BEFORE THE ADMINISTRATOR  
U.S. ENVIRONMENTAL PROTECTION AGENCY

Consolidated Environmental  
Management, Inc./Nucor Steel, Louisiana  
To construct and operate a Pig Iron and Direct  
Reduction Iron manufacturing facility in  
Convent, St. James Parish, Louisiana

Permit No.: 2560-00281-V1 (modified pig  
iron process Title V permit)  
Permit No.: 3086-V0 (DRI Title V)  
Permit No.: PSD-LA-751 (DRI PSD)

**PETITION REQUESTING THE ADMINISTRATOR TO OBJECT TO  
TITLE V OPERATING PERMITS NOS. 2560-00281-V1 AND 3086-V0  
ISSUED TO CONSOLIDATED ENVIRONMENTAL MANAGEMENT, INC. / NUCOR  
STEEL LOUISIANA**

**Figure 1: Carbon emissions coefficient vs. energy content in U.S. pipeline-grade natural gas**

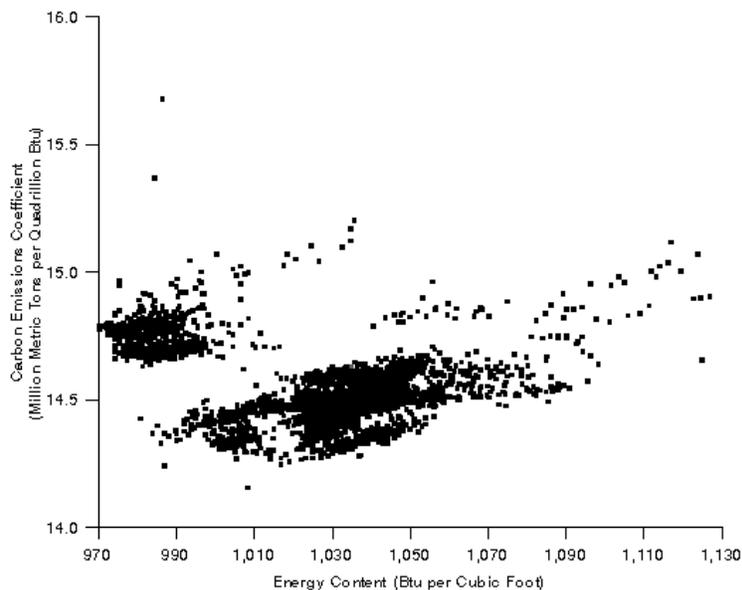
The PSD permit must clearly specify the procedure for making the mass balance calculation for carbon in the DRI production process.<sup>23</sup> Specific Requirement #82, which requires calculating DRI production rates and natural gas consumption “using both the fuel consumption tracking method of Subpart C, as well as Subpart Q for iron and steelmaking from the promulgated Mandatory Reporting of Greenhouse Gas rule” is not adequate.<sup>24</sup>

Subpart Q for iron and steelmaking from the promulgated Mandatory Reporting of Greenhouse Gas rule does not provide a calculation procedure for DRI production and the reference is therefore moot. Therefore, EPA must require LDEQ to develop a calculation procedure for DRI production and present it for public review.

This calculation procedure must account for the fact that the carbon content and heating values of pipeline-grade natural gas can show considerable variation over space and time, as shown in Figure 1.

The U.S. Department of Energy (“DoE”) reports CO<sub>2</sub> fuel efficiency coefficients for pipeline natural gas ranging from 54.01 kg CO<sub>2</sub>/MMBtu (5.401 kg CO<sub>2</sub>/therm) at a higher heating value (“HHV”) of 975-1,000 BTU per cubic foot (“Btu/scf”) of natural gas to 53.72 kg CO<sub>2</sub>/MMBtu (5.372 kg CO<sub>2</sub>/therm) at an HHV of 1,075-1,100 Btu/scf.<sup>25</sup> Given this variability in fuel composition, facility-specific values for carbon content and heating value should be used to determine GHG emissions from natural gas combustion wherever possible. This information should be available from suppliers or Material Data Safety Sheets for the purchased fuel and should be confirmed with fuel analysis results.
